Grandstream Networks, INC

# Request for Class II Permissive Change

FCC ID: **YZZHT70X**

## Original mainboard photo view

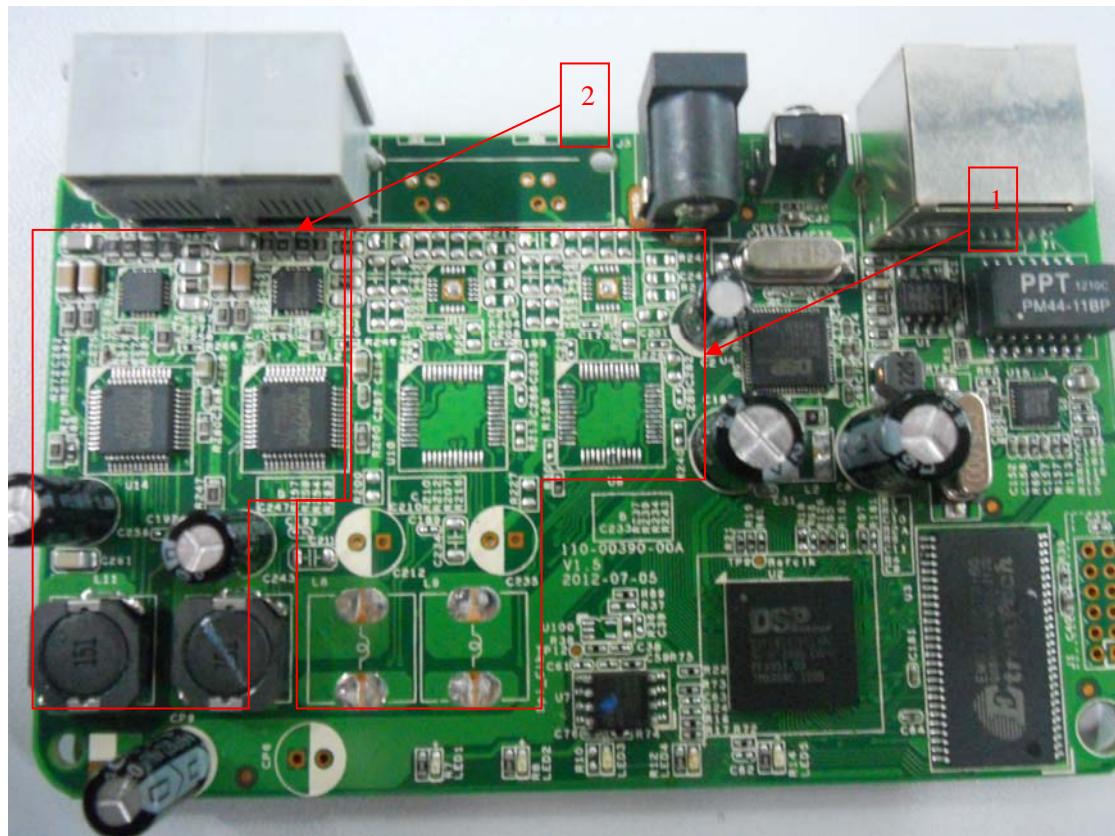
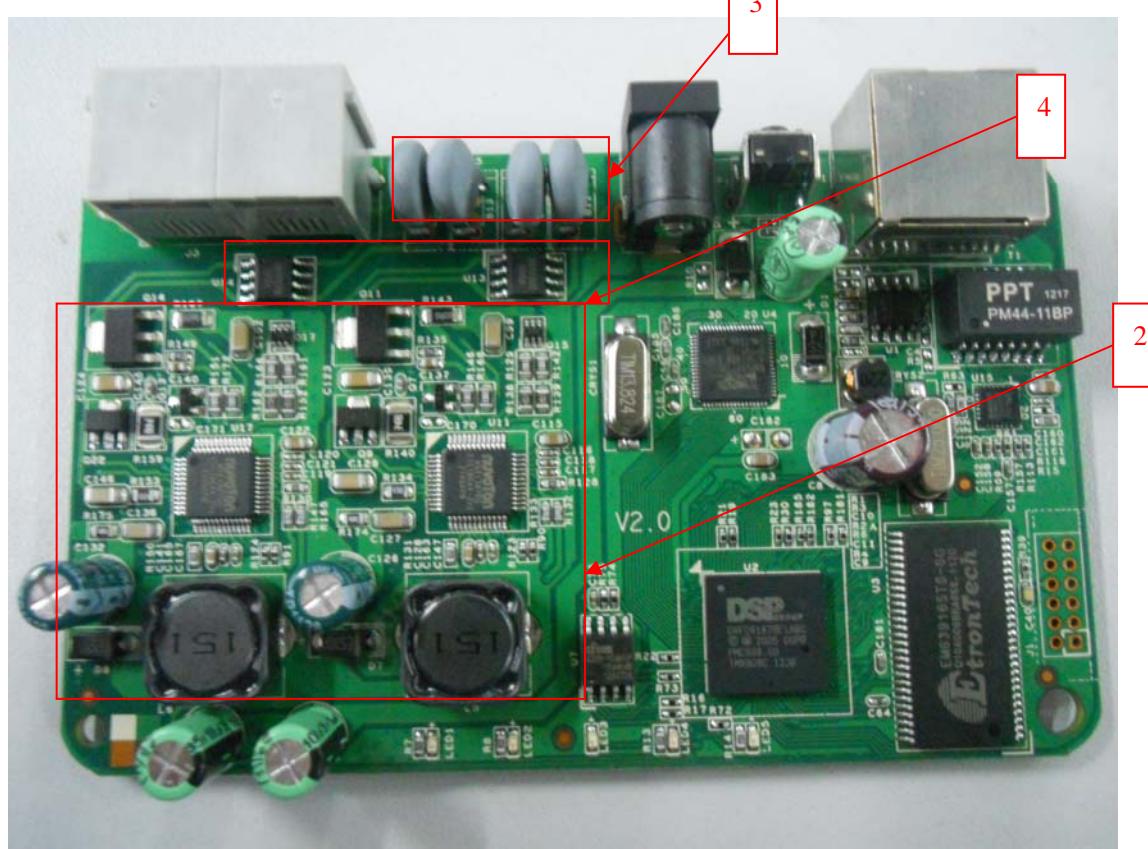
1. Upgraded mainboard hardware version number from Version 1.5A to Version 2.0A;
2. Changed partial PCB layout, for example, we deleted two unused SLIC circuits (see Arrow 1) and replaced two integrated chips (N681622YG) by discrete circuit for better performance (see Arrow2);
3. Added four 50 ohm PTCs (see Arrow 3) and two High Voltage protector ICs for TISP61089 (See Arrow 4).
